UNITED STATES PATENT AND TRADEMARK OFFICE

10/667,535

Office Action Summary

DETAILED ACTION

FIG. 7

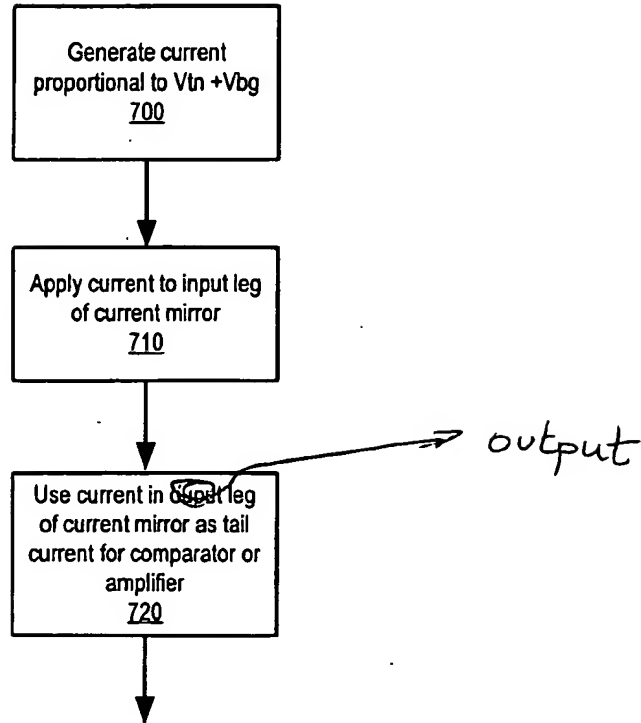
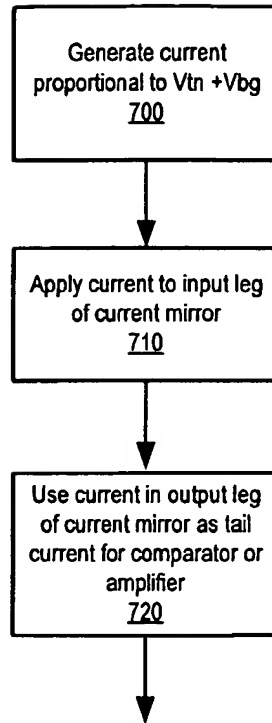
The replacement sheet for Fig. 7 has been approved by the examiner. It overcomes its typo related objection, which has now been withdrawn.

The attached replacement sheet contains a formal drawing that includes changes to FIG. 7. This sheet replaces the originally filed sheet containing the same figure.
